**PLANNING APPLICATION REF: 2009/0350
PLANNING APPLICATION FOR EXTENSION TO EXISTING NETTO FOODSTORE AND
ADDITIONAL PARKING, CIRCULATION AREAS AND LANDSCAPING, HIGH STREET,
GOLDTHORPE**

Further to my letter dated 11 March 2009 to lodge the above planning application on behalf of our client, Netto Foodstores Ltd, please find enclosed four copies of the following revised plans:

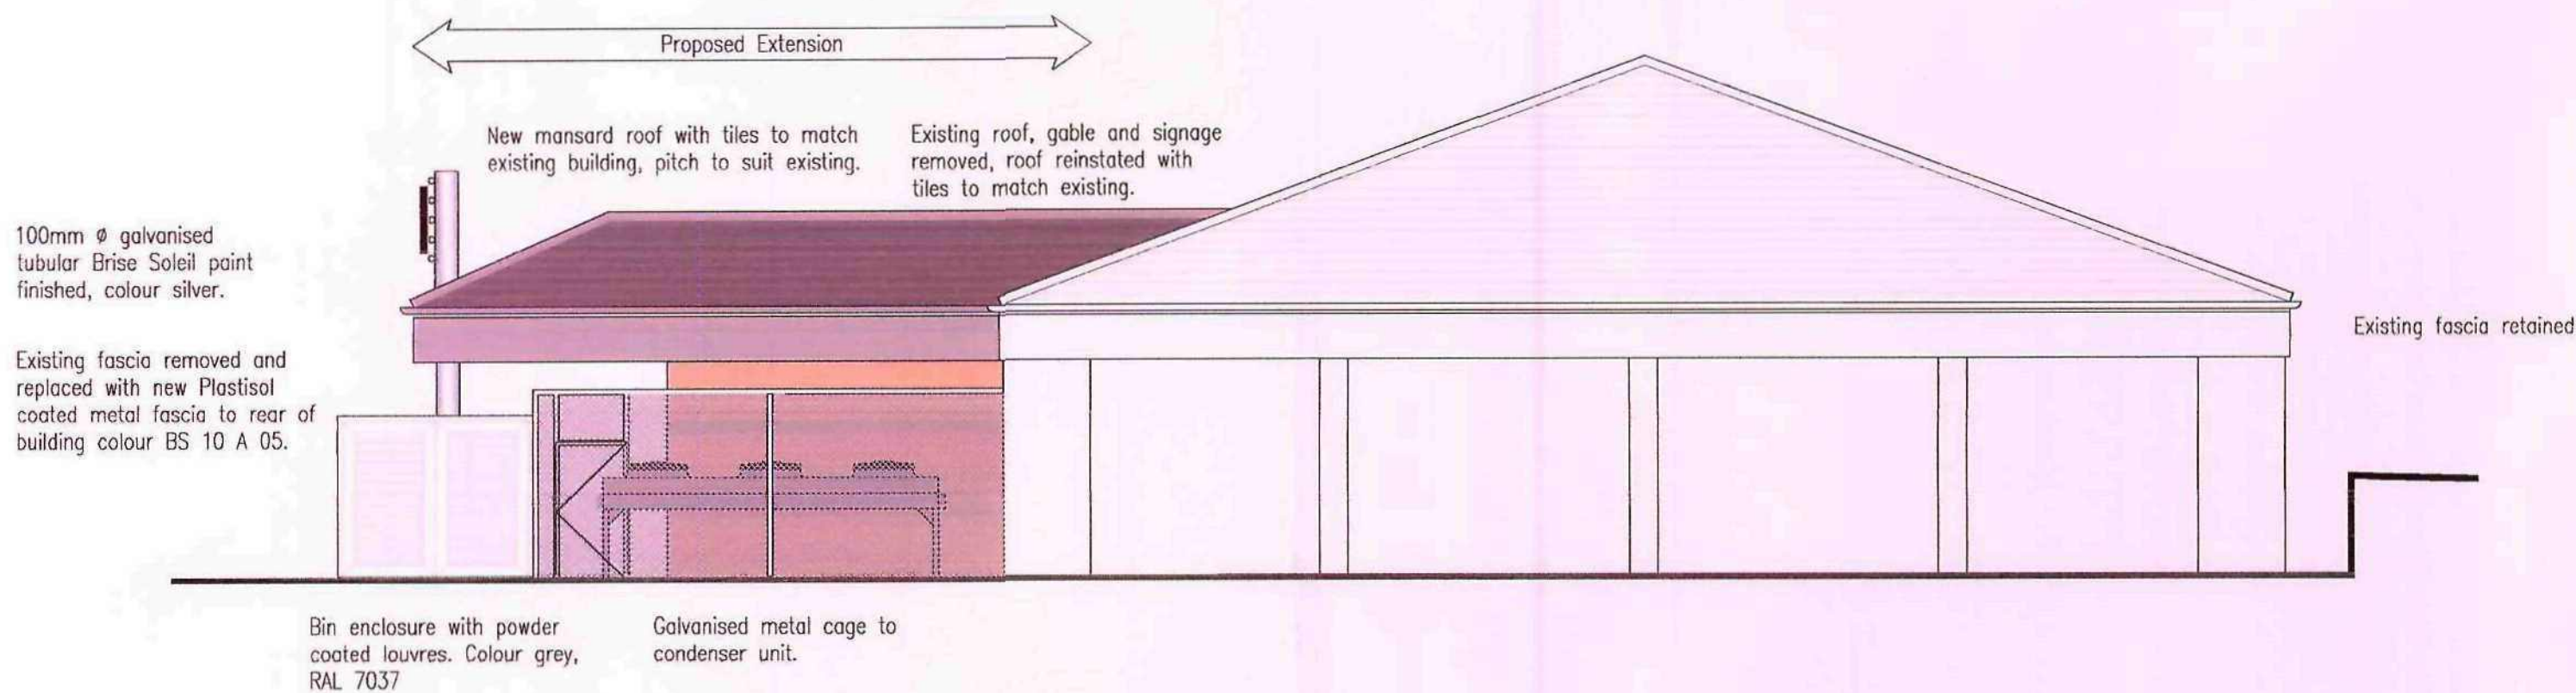
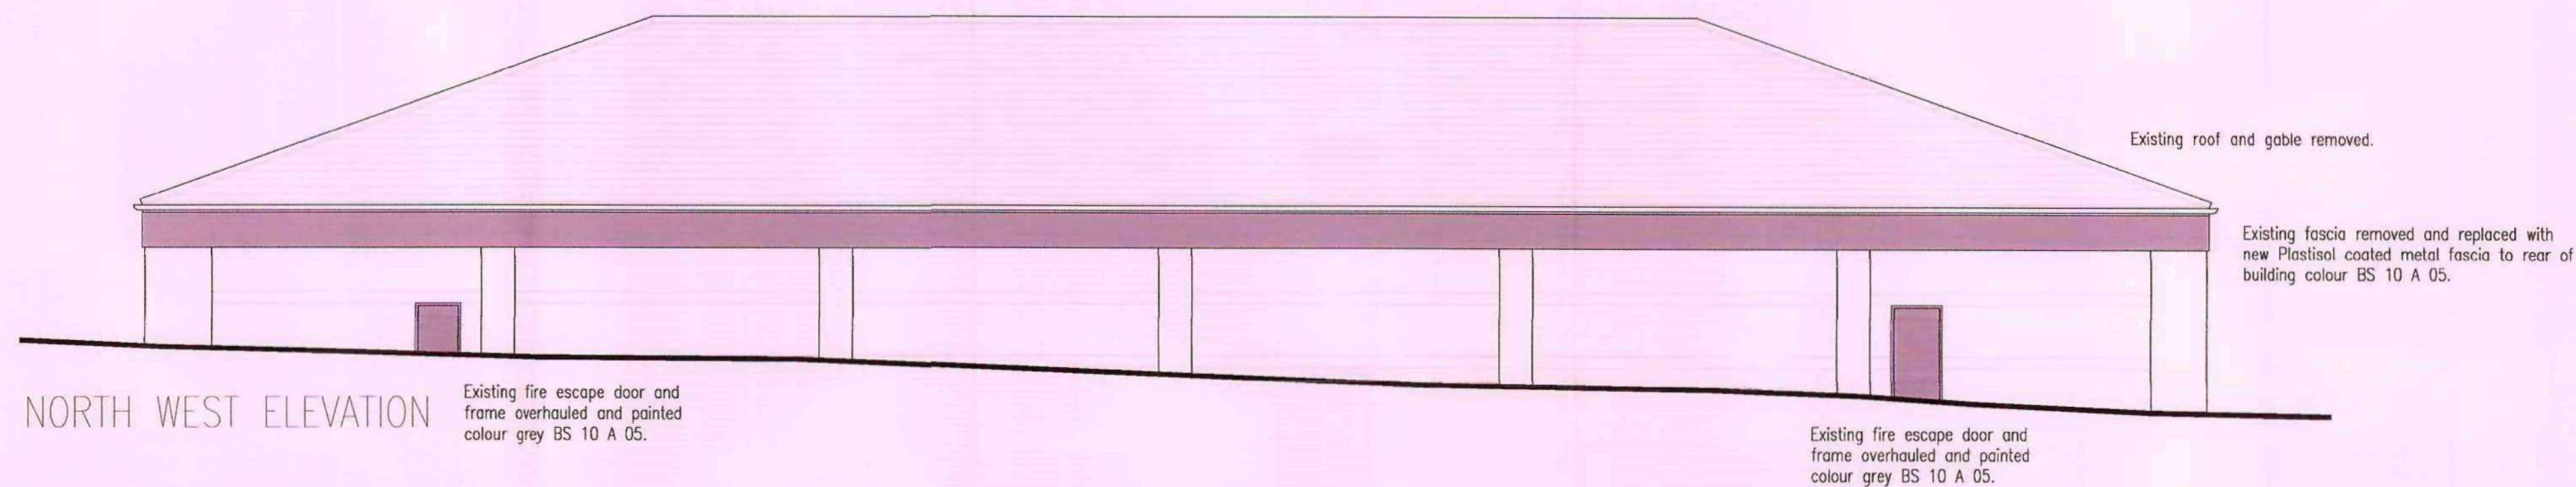
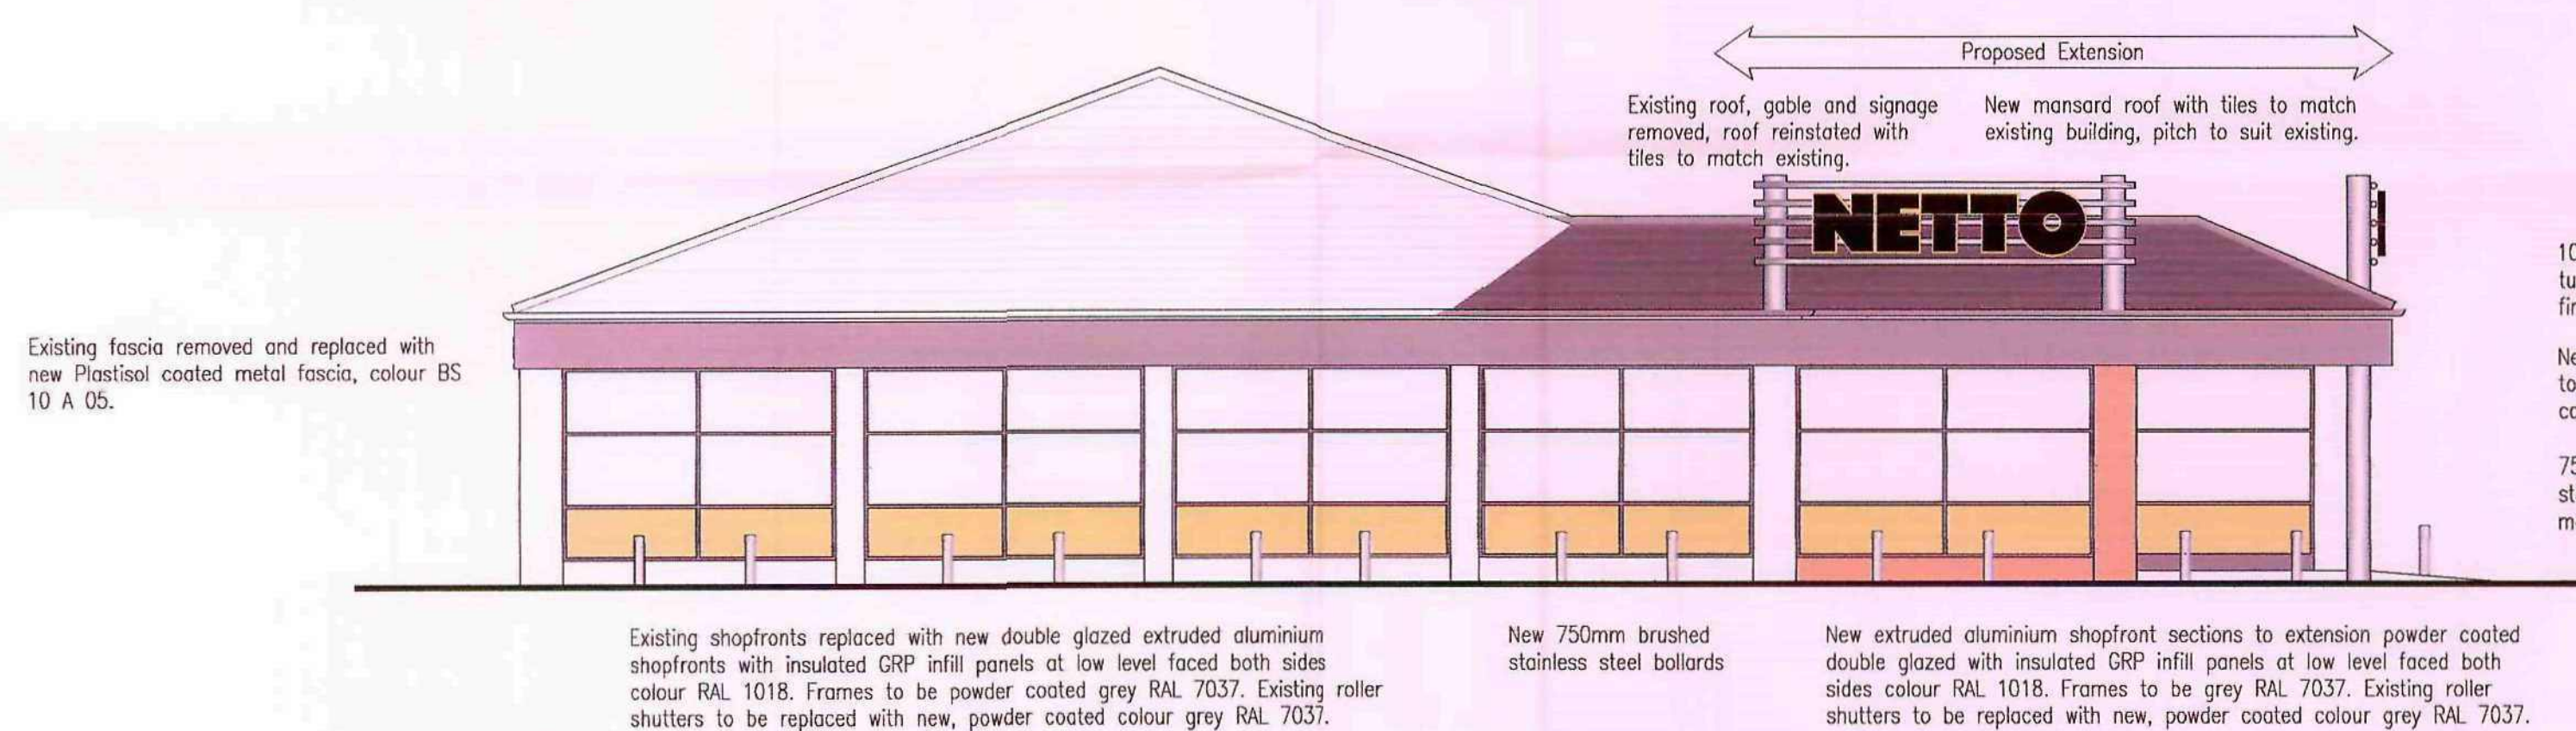
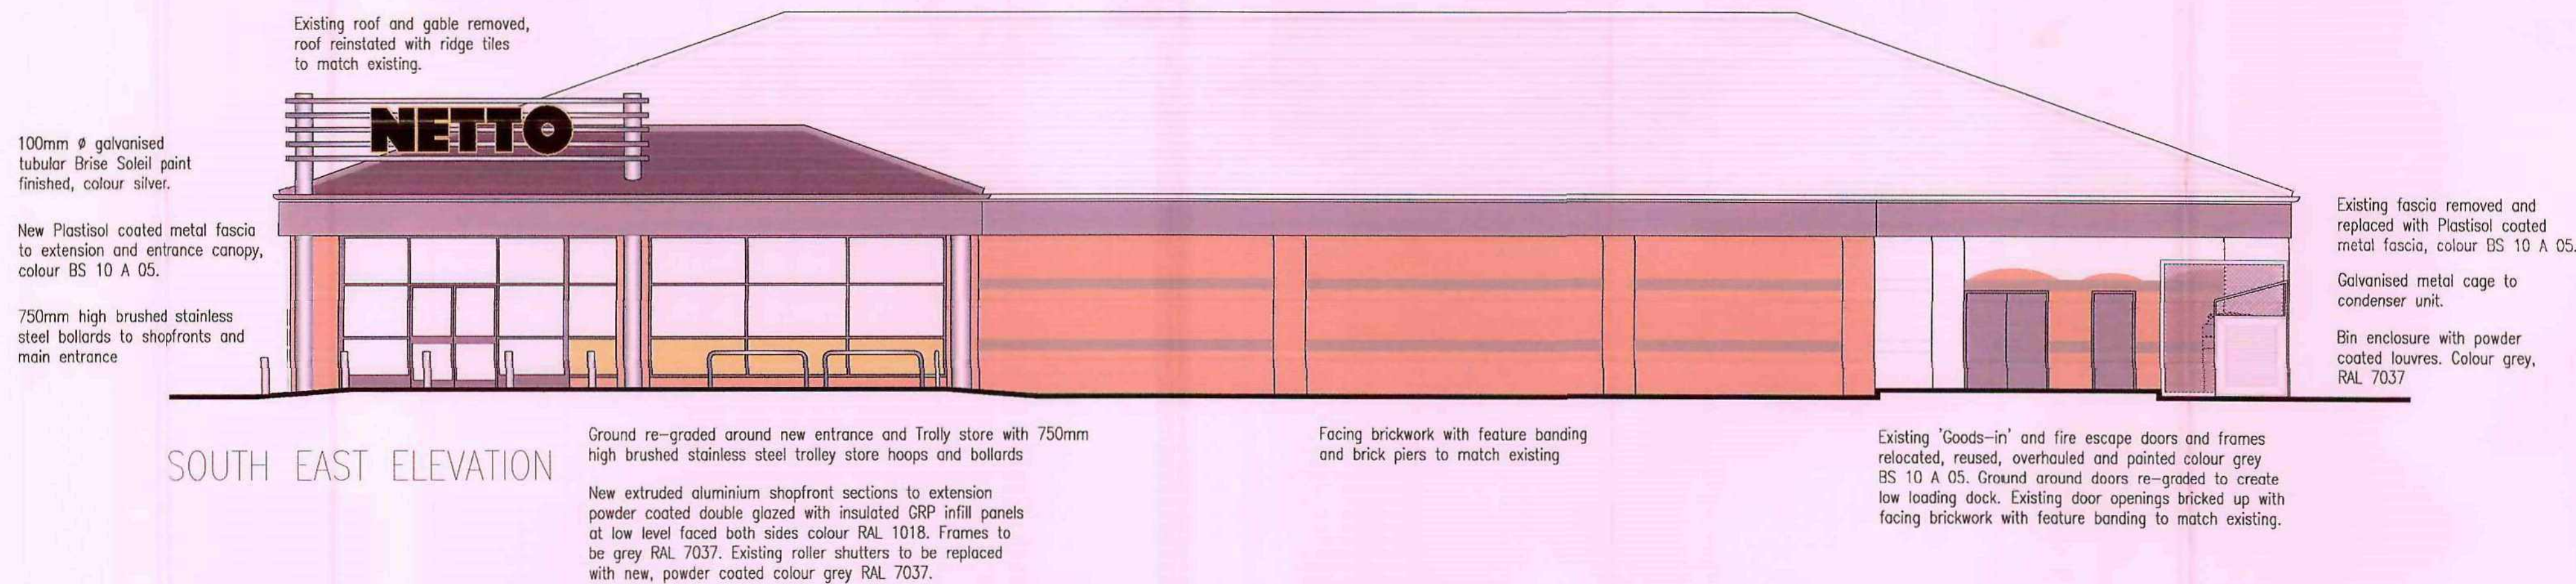
D	17.02.09	Extension also reduced
C	27.02.09	Signage shown to South West elevation
B	19.02.09	Mansard roof shown to replace flat roof.
A	18.11.08	Existing roller shutters replaced with new.
REV.	DATE	AMENDMENT

DRAWING TITLE
PLAN AS PROPOSED

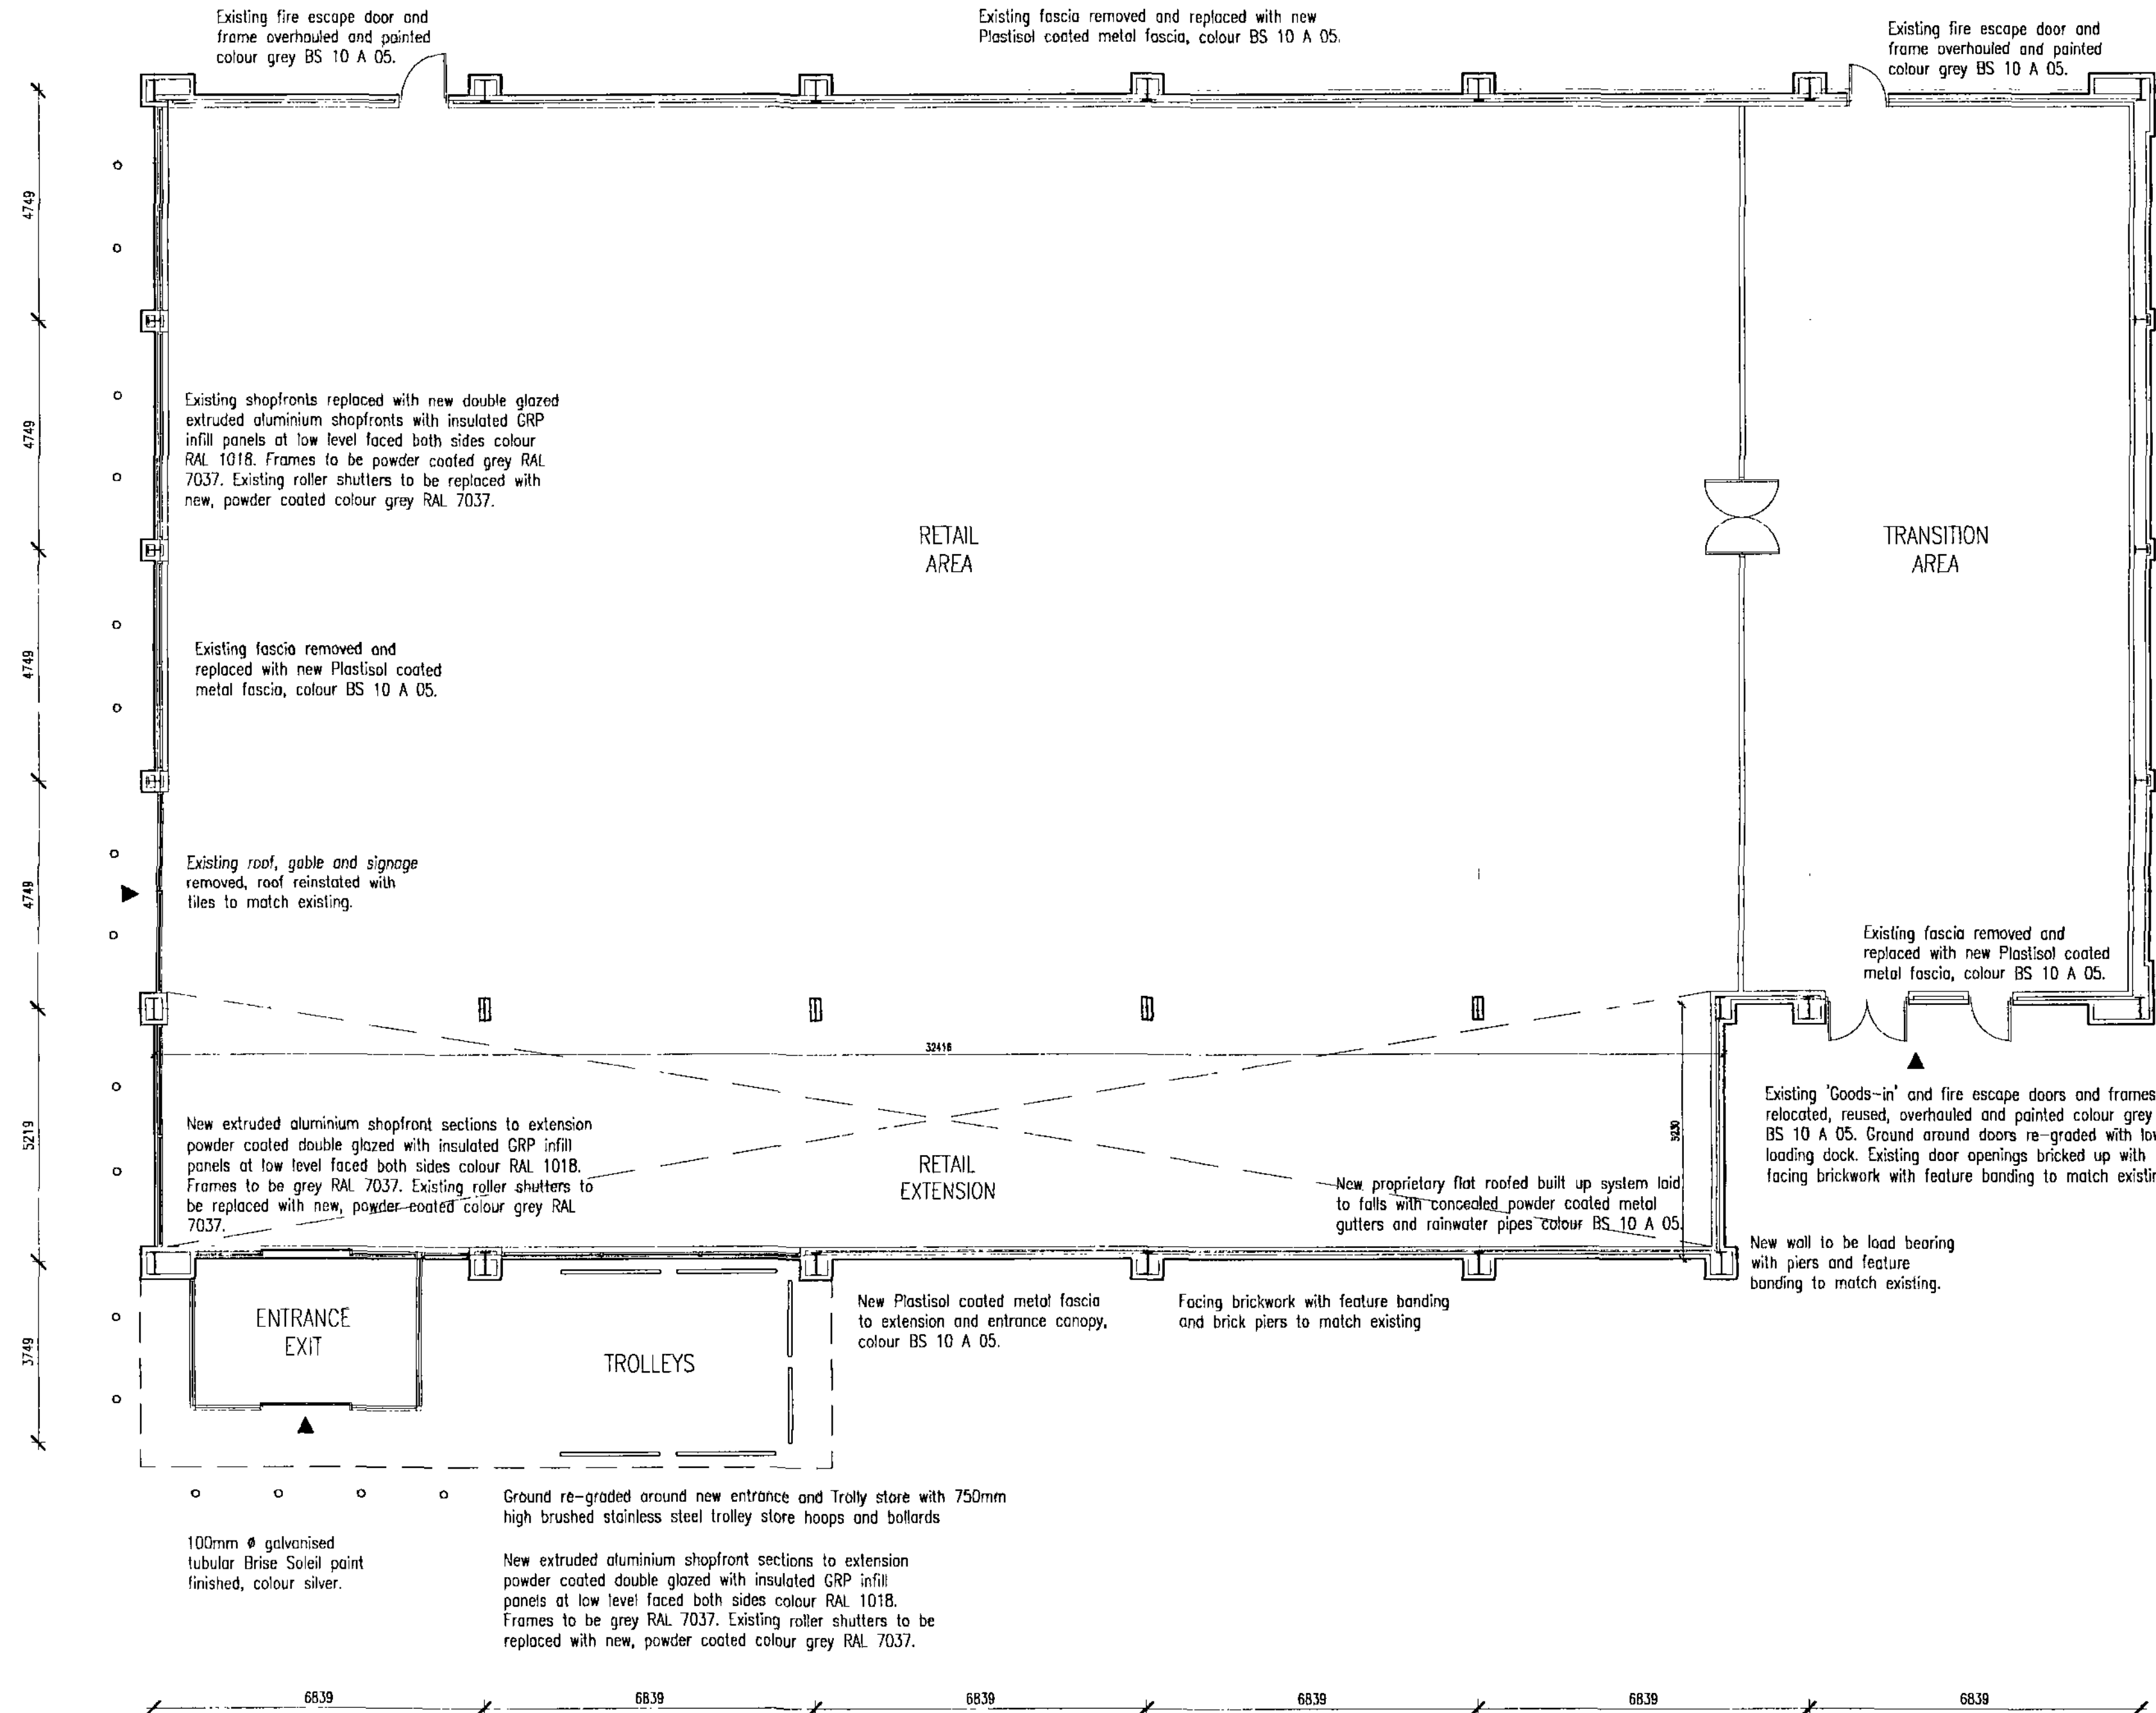
D	18.03.09	Extension size reduced
C	02.03.09	Site layout updated to suit planning consultant comments
B	27.02.09	Site layout updated to suit planning consultant comments
A	18.11.08	Building and access updated
REV.	DATE	AMENDMENT
